Engineering and safety**1.76 Company standards, specifications, manuals, and recommended practices****Reference:**

1.77 Detailed engineering designs

Figure 1.89A-1 Hydrostatic Testing History – Hinton to Hargreaves

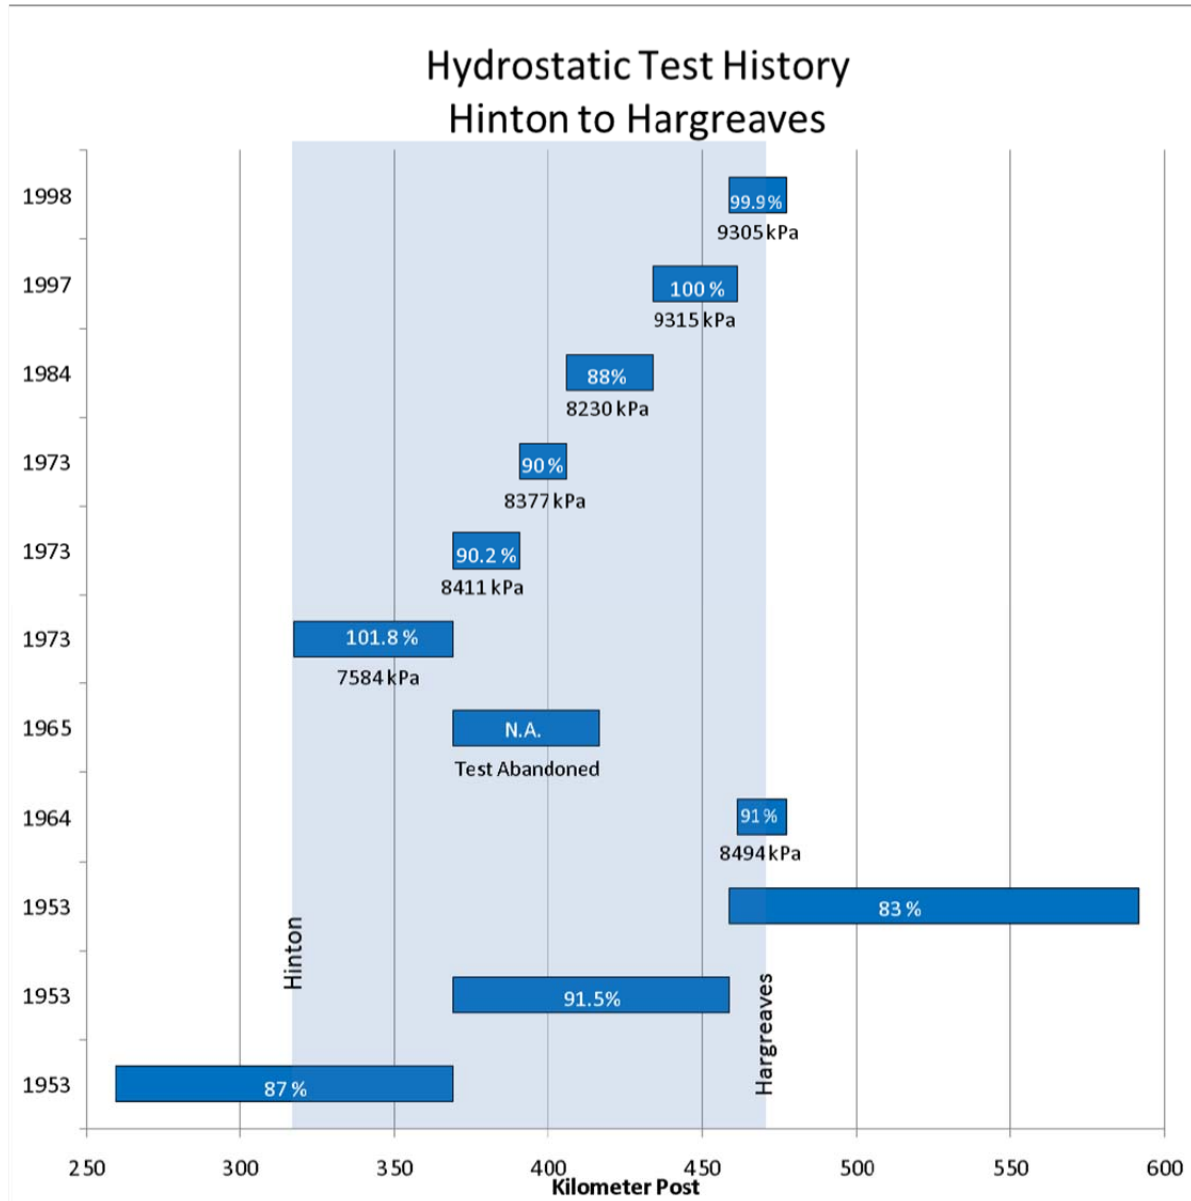
Please provide:

- a) The Application (Volume 4A, Section 3.6.3.5) incorrectly identified that the 1964 and 1965 hydrostatic tests were completed to 100% SMYS. The 1964 hydrostatic test was completed to 91% SMYS. The 1965 test was abandoned following the third failure.

Figure 3.6.1 has been modified to correct the errors in the Application (Figure 1.89A-1). The figure has also been modified to include the pressure achieved at the highest stress location in the test section between 1964 and 1998, indicated in kPa below each test segment.

Figure 1.93e.3-1 Historical Throughputs on Trans Mountain 1953-2012

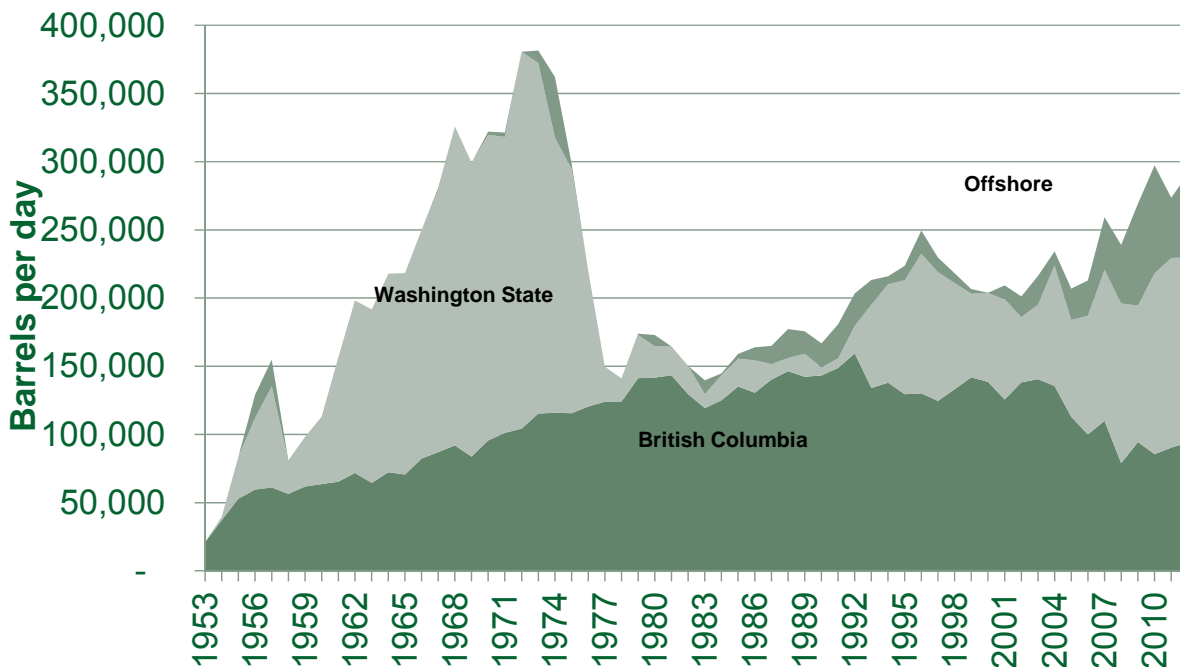
- e.2) copies of any engineering report(s) or a study(ies) to support the response to e.1); and
 - e.3) if the original design flow rate is less than the proposed 58,570 m³/d (368,400 bbl/d) design flow rate provided in Reference ii), explain why only the sections to be reactivated are in the Project scope instead of the entire Line 1;

e.3) Trans Mountain does not consider the original design flow rate when the line was built to be relevant to the proposed Project. The sections of the existing Trans Mountain pipeline that are currently in service, and that will form parts of Line 1, have maximum operating pressures (MOPs) which are accepted and permitted by the National Energy Board (NEB). The location and configuration (the number and size of pump units) of the pump stations for the proposed Project have been selected to make use of the available MOPs, where applicable, but not to exceed them. Many different locations and configurations of pump stations, although not necessarily practical, could be used to achieve higher or lower design flow rates without exceeding the permitted MOPs of the existing active pipeline segments. As indicated in Figure 1.93E.3-1, historical throughputs on the Trans Mountain system reached approximately 60,000 m³/d (380,000 bbl/d) in 1972 and 1973. This was achieved primarily by adding pump stations to the original system. Subsequently, as transportation demand fell, pump stations were removed from the system and the capacity was reduced. Pump stations and pump units were added again to increase the capacity to the current level. The purpose of the configuration proposed for the Project is to achieve the 58,570 m³/d (368,400 bbl/d) deemed necessary to support the planned annual shipments of light crude oil and refined product contract and spot volumes in Line 1.
